800 STEWART

EARLY DESIGN GUIDANCE 2

SDCI#3034006-EG

11.05.2019

MASSING EXPLORATIONS

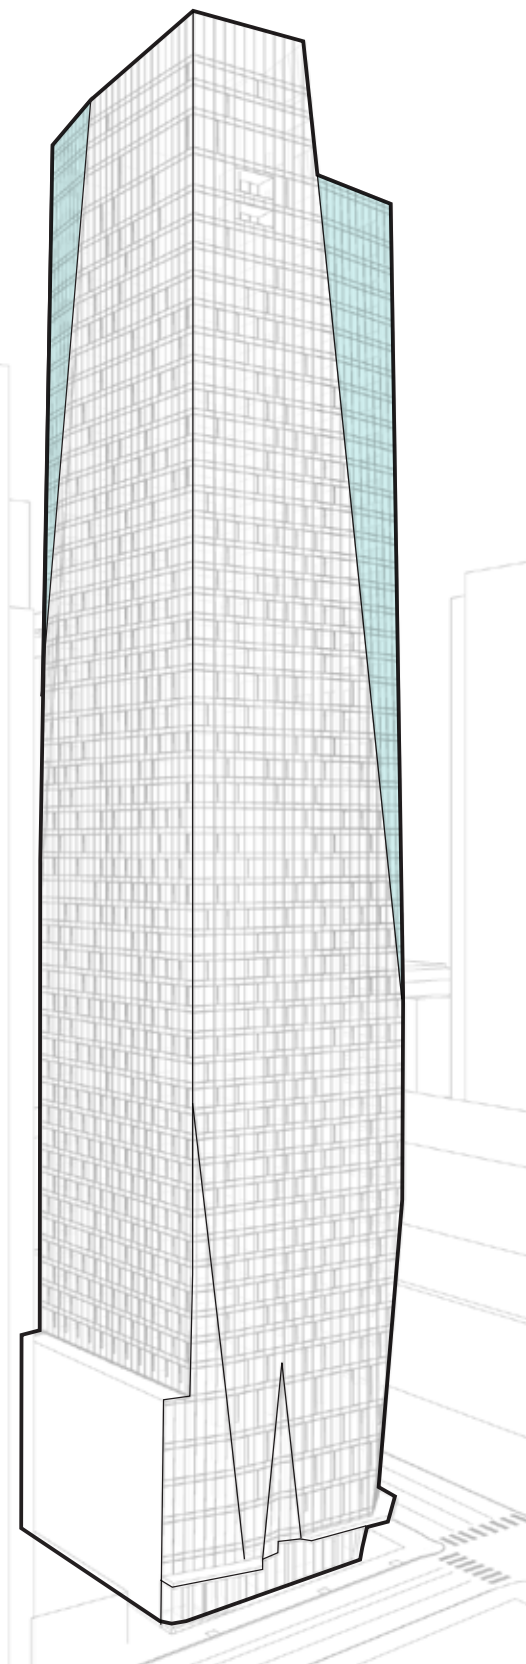
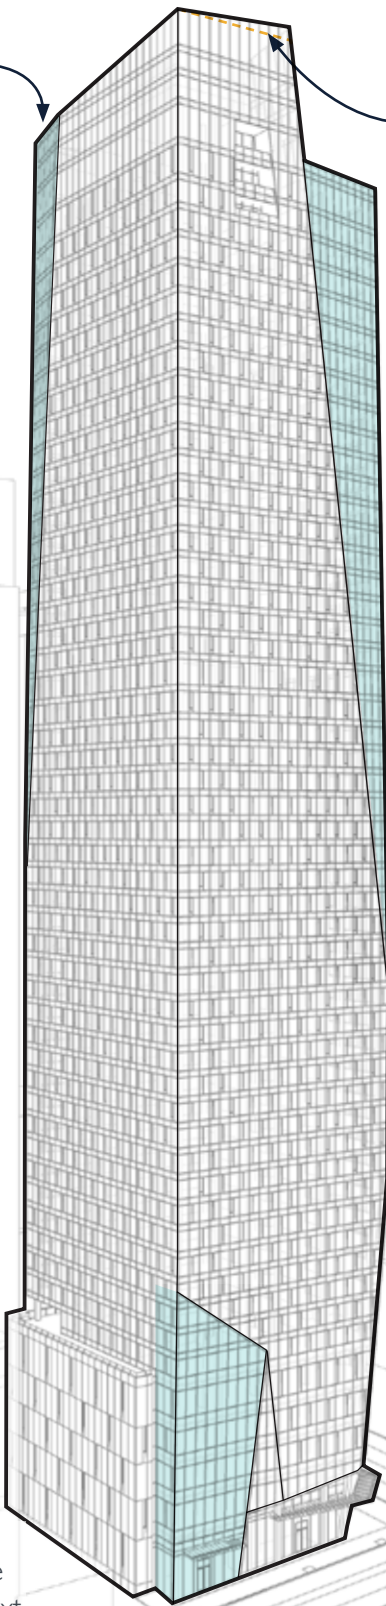
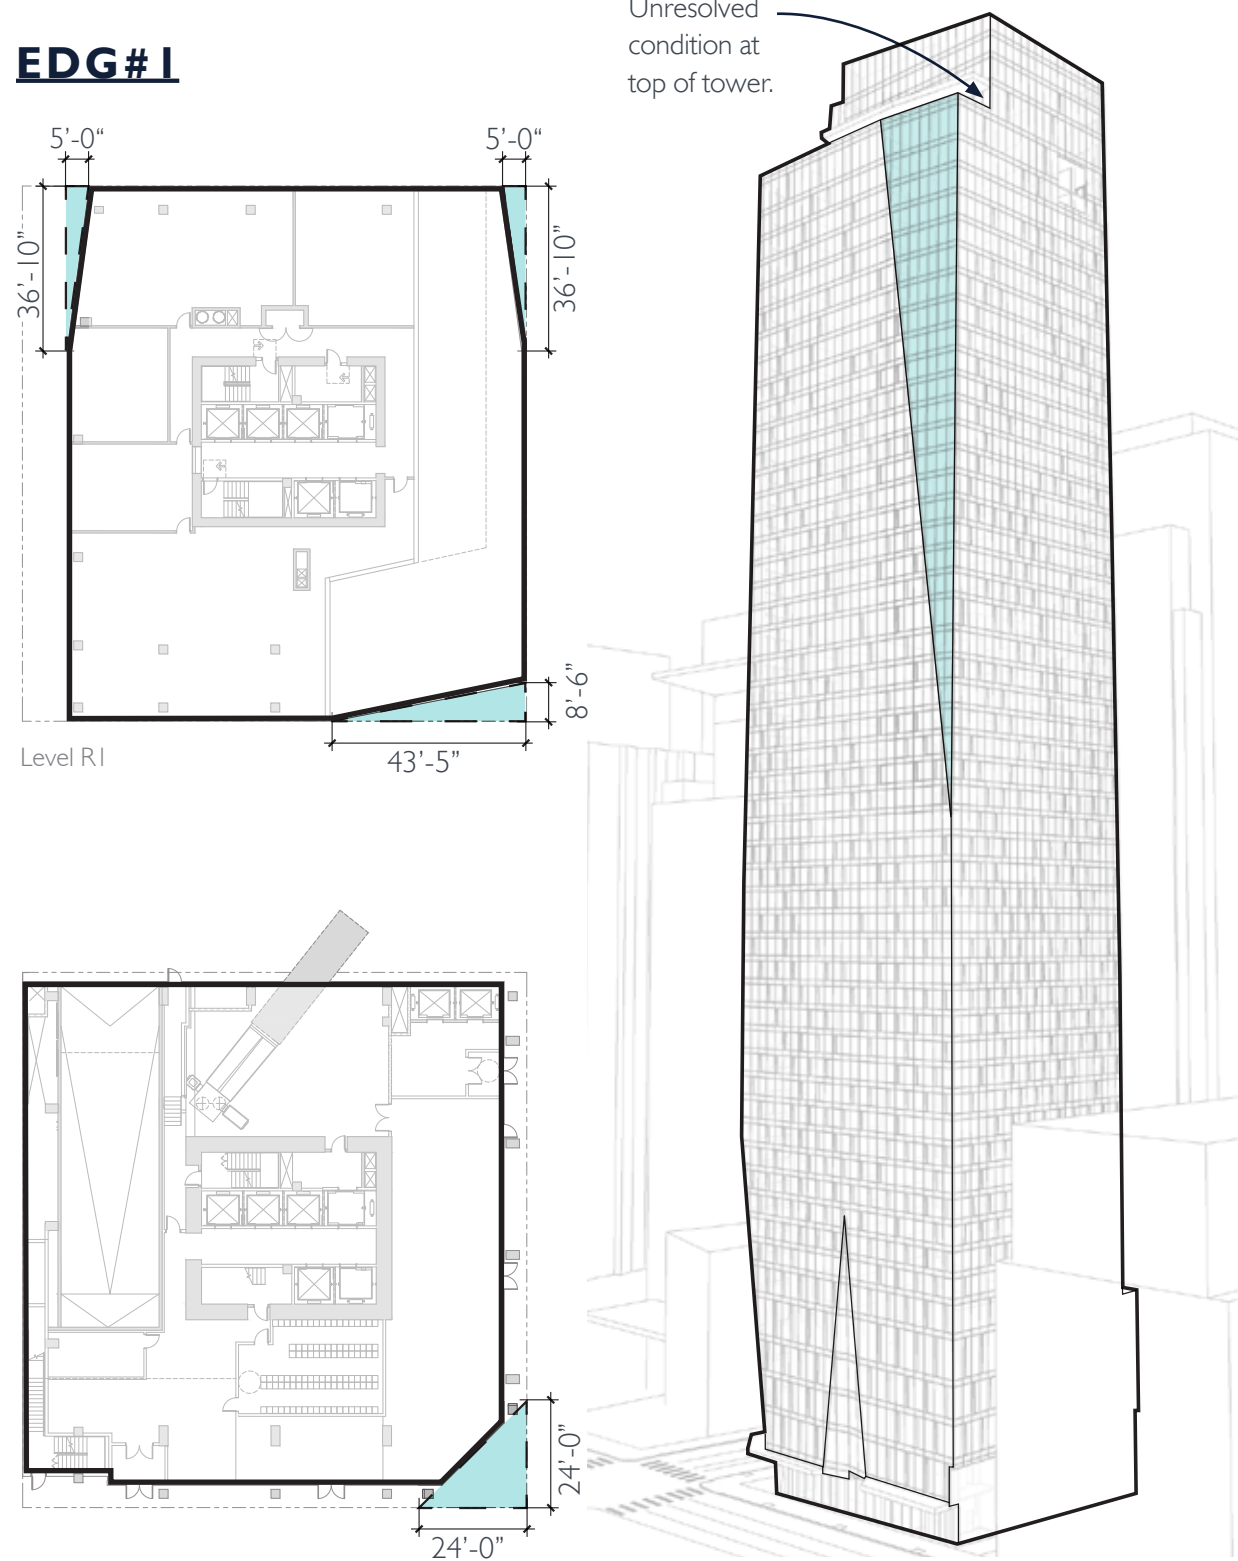
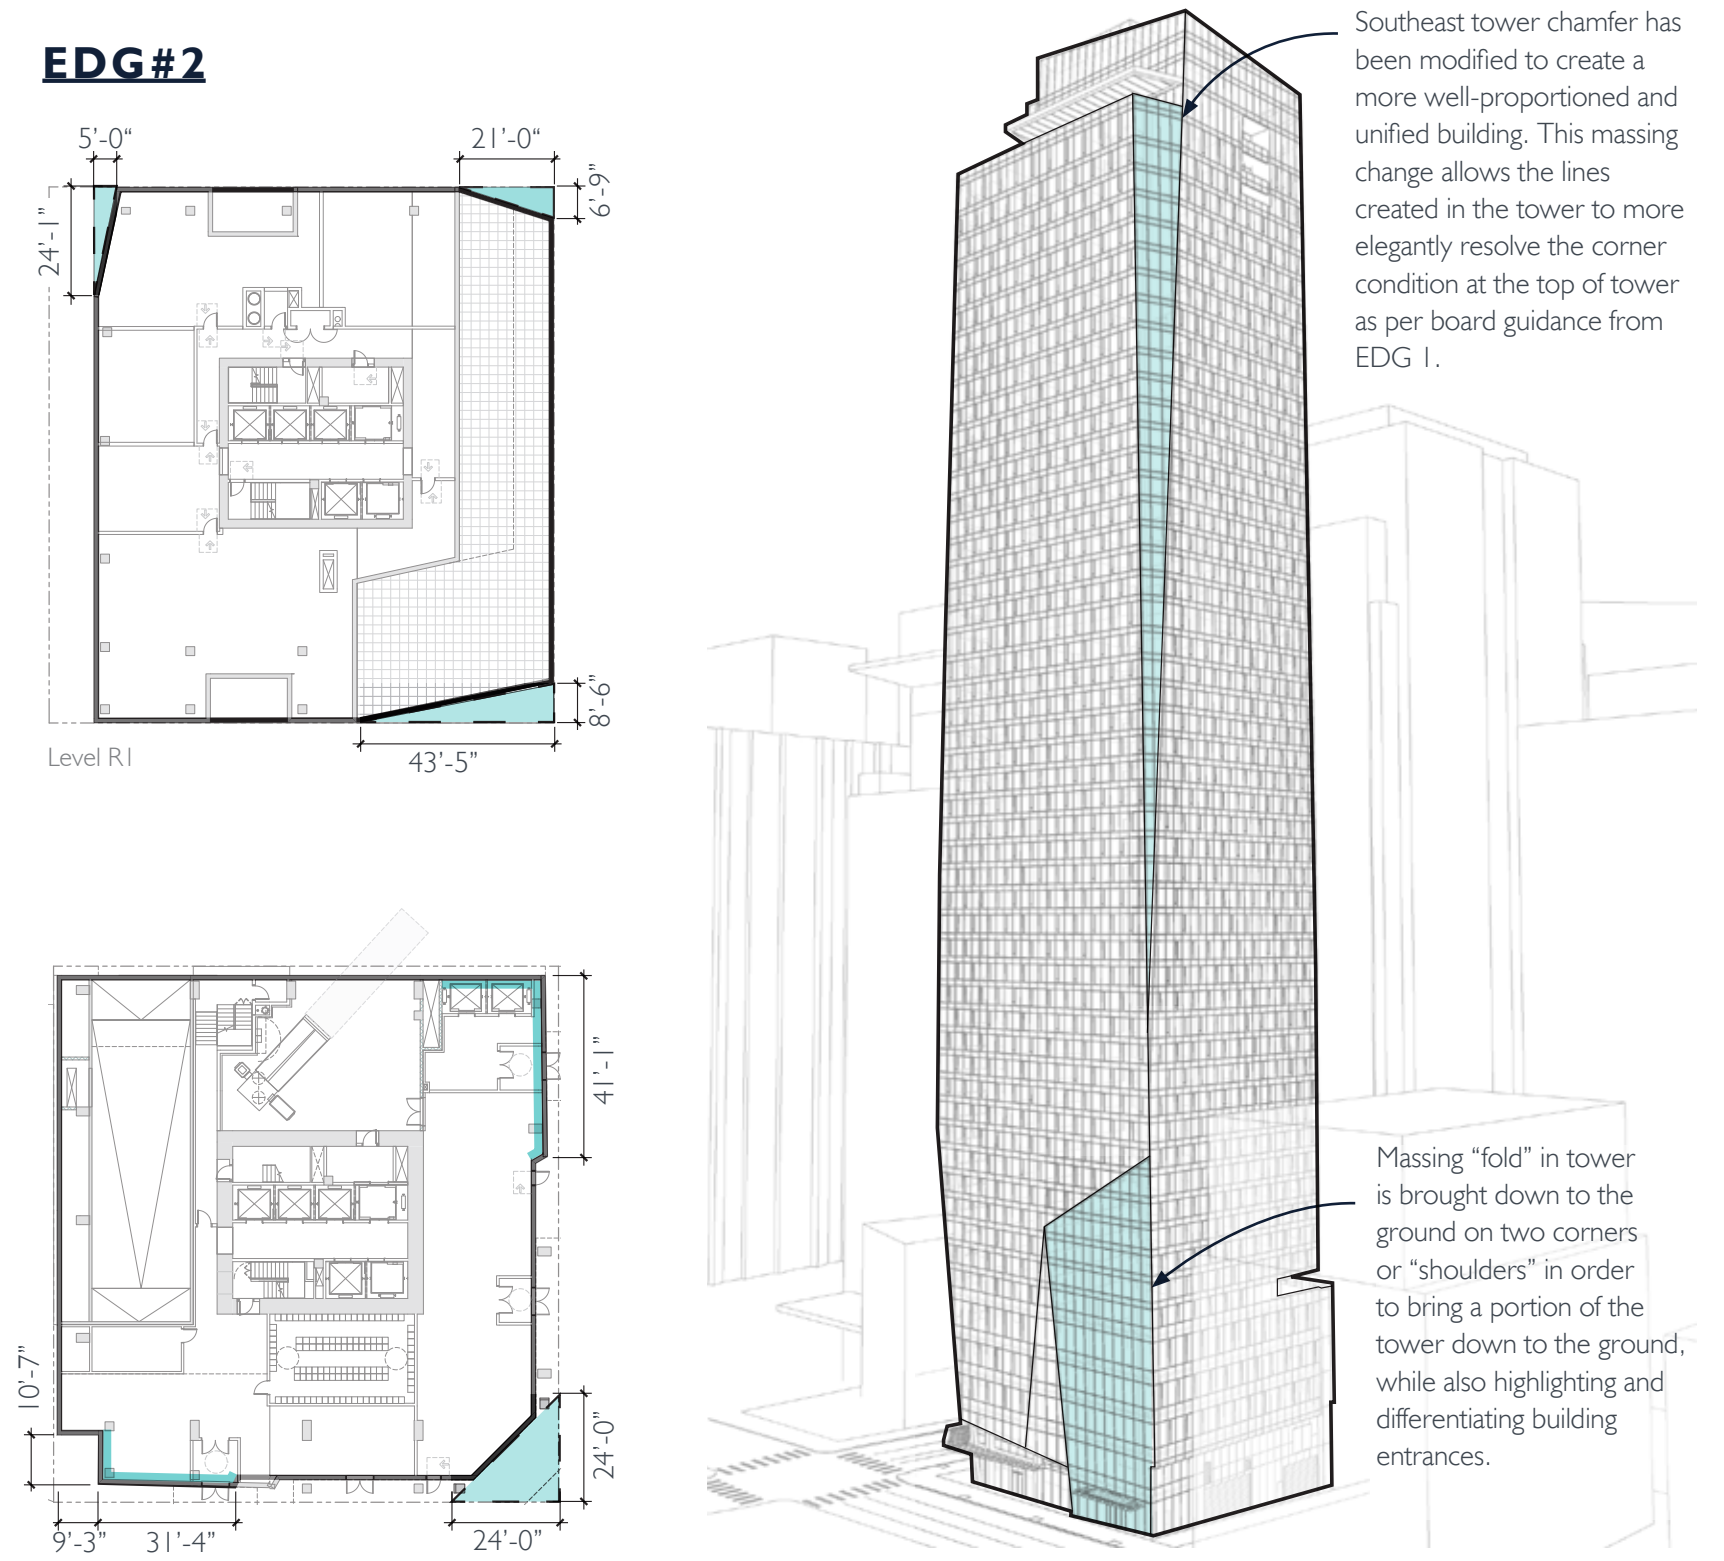
The “Refract” design concept had great potential but that it was only perceptible on the west elevation. The other facades appear conventionally flat and require more development to enhance the skyline and create a unified and well-proportioned design. (A-2, A-1, B-4)

The Board agreed that there were many approaches to strengthening this design concept that could be successful, and asked the design team to specifically demonstrate responses to the following possibilities at the next EDG meeting: Exploration of the location and size of tower chamfers and folds to increase their visual impact (A-2, B-1)

The design team explored the location, proportion and size of the various chamfers and folds in the tower from all sides of the building. The chamfers have been adjusted in order to further enhance the skyline and create a more unified design. The updated massing also more adequately adheres to the design goals of narrowing the top portion of the tower creating a more pleasant and well-proportioned form as well as providing an elegant resolution at the roof. The design team is also using folds at the base of the tower to bring portions of the massing all the way to grade, further ground the design, and creating a stronger architectural expression at the Southwest corner to respond to the corner condition as well as the adjacent open space at the courthouse. The design team studied the tower massing in situ from various popular viewpoints throughout the city in order to maximize the design impact of the major massing moves.

Elongated and adjusted chamfer to improve visual impact and create a more well-proportioned and unified building design.

Created a more dramatic apex at top of tower in response to board guidance, while further enhancing the skyline.

Southeast tower chamfer has been modified to create a more well-proportioned and unified building. This massing change allows the lines created in the tower to more elegantly resolve the corner condition at the top of tower as per board guidance from EDG 1.
